**DEPARTMENT OF TRANSPORTATION**

**National Highway Traffic Safety Administration**

**Federal Motor Vehicle Safety Standards; Electronic Stability Control Systems; Controls and Displays**

**ACTION:** Final rule; response to petitions for reconsideration.

**Figure 1. Rotary Multi-mode Control Example**

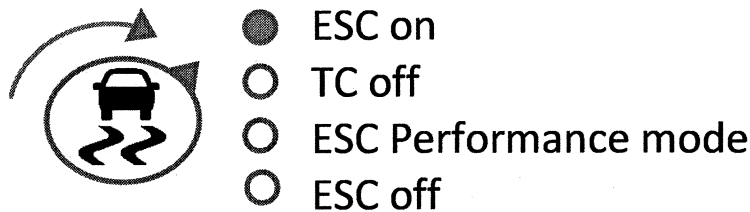
The Alliance/AIAM offered the example of a multi-function control that could be used to turn ESC off or on, but could also be used to turn traction control off and to select an ESC “performance mode.” Because such a control could be seen as neither a control whose only purpose is to disable ESC, nor a control for another system with an ancillary effect, petitioners requested that the agency clarify that multi-function controls like the one described are not prohibited by FMVSS No. 126. Figure 1 below shows a rotary multi-function control (this example was provided in the petition).

*Agency response:* We are granting the petition to clarify S5.4.3, although we note that this question was already answered in the affirmative in the agency’s response to the GM request for interpretation. FMVSS No. 126 does not prohibit multi-function ESC controls that combine the control whose only purpose is to disable the ESC system with controls used for other purposes. Paragraph S5.4 specifically allows controls whose sole purpose is to disable ESC and establishes various requirements for them. The only reason that the standard distinguishes between these controls used only for disabling ESC from those used to control systems with an ancillary effect on ESC is to express the labeling requirements for the control symbols. The multi-function control example presented by the petition combines several controls in a single piece of hardware: one control whose only purpose is to disable ESC, one unregulated control for the traction control system, and another control that places the ESC system in an intermediate “sport” or “performance” mode.”

In the rotary multi-function control example of Figure 1, the function within the control that disables ESC, because its only purpose is to disable ESC,

would be required to be identified using the symbol or text specified in FMVSS No. 101 for “ESC Off” (effective September 1, 2011) on or adjacent to that part of the control. We would not consider the precise example given by the Alliance/AIAM petition as satisfying FMVSS No. 101’s requirement that the “ESC Off” label (“identifier”) be adjacent to the control it identifies, because the telltale lamp is located between the two.<sup>16</sup> However, this problem could be solved by moving the lamp to the other side of the label.

FMVSS No. 126 does not specify requirements for the “TC off” function in the example, nor for the “ESC Performance mode” function, unless that function within the control places the ESC system in a mode in which it no longer satisfies the standard’s performance requirements. If it did, it would be considered an “ESC Off” control (because it is a control whose purpose is to place the ESC system in a mode in which it no longer satisfies the performance requirements) and would also have to be labeled accordingly.
